Meeting: Traffic Management Meeting

Date: 21 November 2013

Subject: Flitton and Greenfield – Consider Objections to Proposed

Speed Limits

Appendix A – Drawing of Proposed 40mph Speed Limit in Flitton Hill

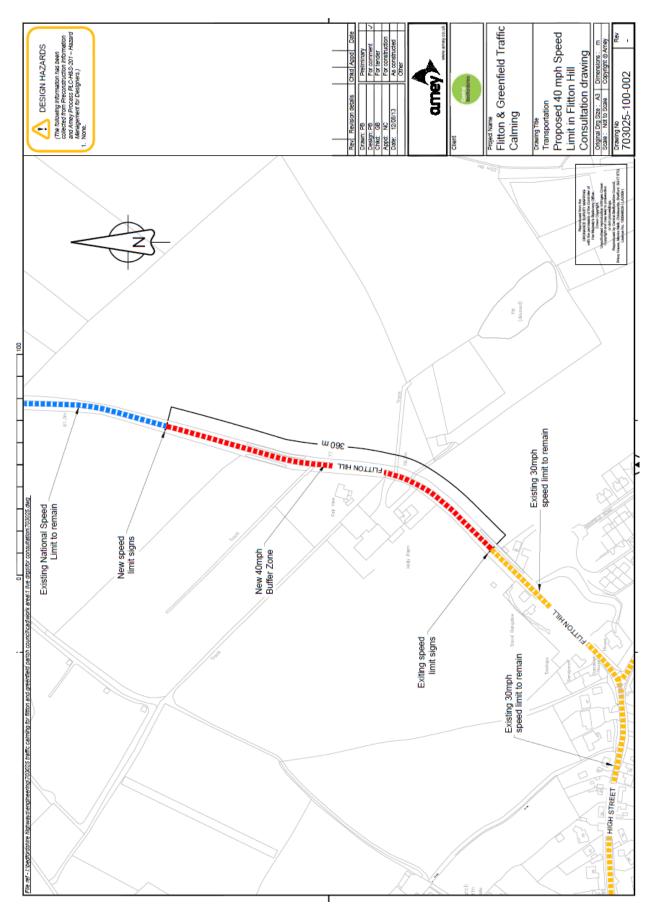
- 3. Flitton and Greenfield Parish Council objects to the proposed 40mph speed limit on Flitton Hill. A copy of the correspondence is included in Appendix D. The main points of objection are summarised below:

- a) The existing 30mph speed limit should be moved northwards to the point where the proposed 40mph limit would start. At present drivers heading up Flitton Hill leaving the village can see the national speed limit signs and begin to accelerate, resulting in unacceptably high vehicle speeds. The proposed 40mph limit will not significantly help in this respect.

- b) The Parish Council's preferred option would be to extend the 30mph speed limit and introduce a 40mph buffer zone outwards to the Ampthill Road junction, thereby covering outlying properties.

- c) Flitton Hill has no footway and is regularly used by pedestrians, cyclists and horse riders, which are put in danger by excessive vehicle speeds.
- 4. Two residents have submitted representations on the proposed 20mph speed limit in Greenfield. Copies of the correspondence are included in Appendix D. The main points of concern are as follows:

The new proposed 40 mph limit leading to Flitton Hill is a speed limit and not as I was under the impression only going to be a buffer zone (less than 200 meters) Should this go ahead it must be realised that the chances of enforcement are virtually nil."

Objection to 40mph speed limit on Flitton Hill

I object to the proposal to introduce a 40 mph buffer zone as detailed in the consultation. I have discussed this at length with residents on Flitton Hill and also raised with the full Parish Council.

At the Parish Council meeting this evening it was agreed that the Parish Council object to the proposal to leave the 30 mph speed limit on Flitton Hill where it is. As a Parish Council we asked Amey that the 30 mph sign be moved or other measures be introduced to achieve the same effect of reduced speeds on Flitton Hill. Whilst the proposed introduction of a 40 mph buffer zone may reduce the speed of traffic entering the village, it will do nothing to reduce the speed of traffic travelling up Flitton Hill to leave the village. The position of the current end of speed limit sign encourages cars to accelerate sharply from the bottom of Flitton Hill, which is one of the reasons why we asked that the sign be moved so that it was out of sight of traffic travelling up the hill. We are not confident that a 40 mph sign replacing the no limit sign in the same position will reduce this effect.

Our preference is for the 30 mph sign to be moved the 360 m to the position of the proposed entry to the 40 mph zone and the 40 mph buffer zone extended from there to the junction with Ampthill Road. This will not only remove the incentive for cars to accelerate as they leave the built up area, it will also include the properties at the top of the hill and the village allotments within the 30 mph zone. This is important as these have concealed entrances. A 40 mph buffer zone extending to the junction with Ampthill Road is also important because there is a blind corner and junction with a farm road immediately after a vehicle enters Flitton Hill from that junction.

Flitton Hill is regularly used by walkers, joggers, cyclists and horse riders. There is no pavement for pedestrians, even in the built up section. It is a narrow road. The traffic speeds dangerously and something has to be done before there is a serious accident. Our preference for a 30 mph zone extended past the last property and the allotments on the top of the hill and 40 mph zone from there to the junction with Ampthill Road would not cost any more than the current proposal. Instead of a new gated entrance with 40 mph signs by the allotments and new signs to replace the existing 30 mph/no limit signs with 30 mph/40 mph signs there would be a new 30 mph gated entrance by the allotments with new 40 mph/no limit signs at the Ampthill Road junction.

The Parish Council are not happy to proceed with the current Amey proposals and would like to know whether the alternative outlined above can be implemented instead and if not why not. I would be happy to discuss this in more detail.

- 6. Bedfordshire Highways' response to the points above in relation to the proposed 40mph speed limit in Flitton Hill are as follows:
 - a) It is felt that the extent of the existing 30mph is correct in that it covers the main built-up part of the village. If the 30mph speed limit was extended to the length of Flitton Hill further north where roadside development is very sparse, drivers would fail to understand the need for such a low limit and compliance would be poor. This could lead to abuse of the 30mph limit on that length of Flitton Hill where it is really needed.

- b) The proposed 40mph speed limit is intended as a buffer zone, which should result in lower speeds as drivers enter the 30mph speed limit. This should lead to better compliance with the 30mph limit. A longer extension of the 40mph limit covering mainly open countryside would not be understood by drivers and would be ignored by many.

- c) It felt that the proposal offers the best road safety solution for all road users. The combination of 30 and 40mph speed limits should lead to an overall reduction in vehicle speeds and consequential safety benefits.

It is recognised that the proposed 40mph speed limit on Flitton Hill extends further than normal for a buffer limit, but it has been designed to cover outlying properties and to ensure good forward visibility of the terminal signs.

Appendix B – Drawing of Proposed 20mph Speed Limit in Greenfield

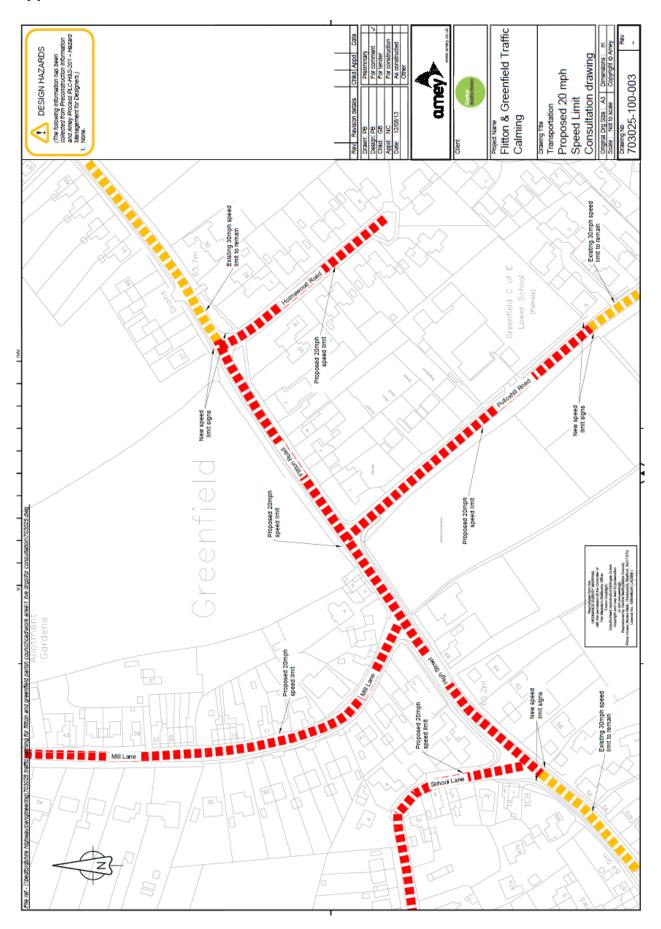
- a) The proposed 20mph zone is welcome, but does not go far enough. It is suggested that the whole village be covered by a 20mph speed limit, or at least that part of Greenfield Road, Flitton near to the village hall and playing field.

- b) Drivers will be accelerating/decelerating in the area near to the 20mph/30mph speed limit change over point, thereby increasing noise and risk to adjacent residents.

- c) The frequent speed limit changes will confuse drivers.
- 5. Bedfordshire Police's comments are as follows:-

Further calming would be required on the High Street and Pulloxhill Road to ensure conformity of the new proposed speed limit.

Representations on proposed 20mph speed limit in Greenfield

I support the move to introduce 20mph limits, but I cannot see the rationale for the mixture of 20 and 30mph limits.

If the 20mph limit is designed to increase safety in the area around the school, why doesn't this same argument apply to the area around the Village Hall and children's playground on Greenfield Road? Has the village hall and children's playground area been considered in need of a 20mph limit?

If a 20 limit is followed by a 30 limit, this places my house in an acceleration and deceleration zone, increasing both noise and risk. Has the impact of this been assessed?

The changes in limits also risks creating confusion, as there will be three limits (40, 30 and 20) all within a very short road length. Is there evidence that drivers are able to make sense of and adhere to such a series of changing limits?

The driver time saving of retaining a stretch of road at a 30mph limit (rather than continuing the 20 limit throughout Flitton and Greenfield) amounts to less than 60 seconds over the less than a mile from the start of Flitton Road to Flitton Hill. Has this time saving been assessed as critical as against the increased safety of continuing the 20mph limit to include the village hall and children's playground?

We therefore welcome the planned 20mph speed limit through parts of Greenfield although we do not think the plans go far enough. We strongly believe that the 20mph speed limit should apply on entrance to Greenfield (at the Flitwick end) right through to Flitton. Our reasons are:

- Varying the speed limit within Greenfield (as per the current proposals) is likely to cause confusion and irritation and result in the limits being broken.

- Removing the 20mph limit and increasing to 30mph within Greenfield (just after Holmewood Rd) is likely to cause drivers to accelerate into the 30mph zone, which is both dangerous and disruptive to residents in that area, with the associated engine sounds of acceleration.

- Relating to this, with drivers likely to accelerate hard out of the 20mph zone and into the 30mph it is likely that they will accelerate even beyond 30mph. This is evidenced by the behaviour of drivers as they accelerate on exit from but are still inside Greenfield (at the Flitwick end) in anticipation of the 40mph and national speed limit zones.

- 7. Bedfordshire Highways' response to the points above in relation to the proposed 20mph speed limit in Greenfield are as follows:
 - a) 20mph speed limits and zones are applied to roads that either have traffic calming measures or the road layout, width and characteristics naturally lends itself to lower vehicle speeds. They are typically used in residential streets, town centres or at locations with a high proportion of vulnerable road users, such as near to schools. The part of Greenfield that would be covered by the proposed 20mph limit is the most heavily built-up part of both villages, contains a school and has some physical speed-reducing measures. It is anticipated that drivers will understand the need for a 20mph limit and compliance will be reasonable. If a 20mph limit was applied to a wider area, this would lead to a high level of abuse and driver frustration

- b) Given that drivers will only be adjusting their speed by 10mph it is expected that any acceleration/deceleration will not be too severe and any consequential increase in noise will be negligible.

- c) It is becoming more common for drivers to encounter regular speed limit changes as a result of buffer zones on the edges of settlements, 20mph limits and the overall 30mph default limit in built-up areas. Hence, motorists should get more familiar with seeing a range of different speed limits and adjusting their behaviour accordingly. It is felt that the changes proposed for Flitton and Greenfield will not lead to an unacceptable mixture of different limits and will be easy for drivers to understand.

There are already some speed reducing measures in place in Greenfield and a raised table is proposed to be installed near to the Flitton Road/Pulloxhill Road junction. No objections were received to that proposal.

If implemented, compliance with the proposed 20mph speed limit will be monitored and if necessary further traffic calming measures will be considered.
